# **Optima Plus® EBF-85**

PARTS LIST-EBF-85 FAUCET

# **SOLENOID VALVE CHANGES**

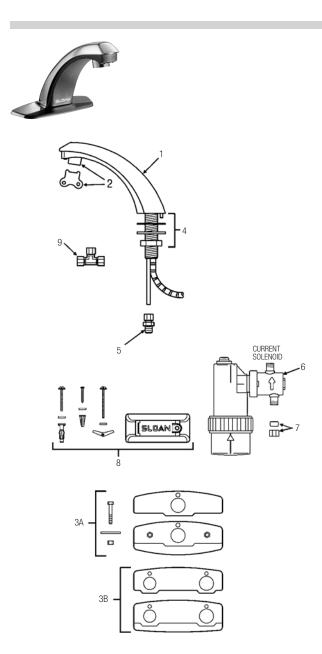
The current solenoid (in production since May 1998; part 7 shown on the left) has MALE inlet and outlet connections. The current style filter plug has a metal filter cap that can be removed with a 5/8" wrench.

The older solenoid valve (shown on the left) can be identified by FEMALE inlet and outlet connections. These require EBF-17 compression fittings (part 10 shown on the left).

This older style solenoid has either a plastic or a replacement brass filter cap. Remove the older brass filter cap with a 7/16" or 1/2" hex wrench. Replace the old style filter cap.
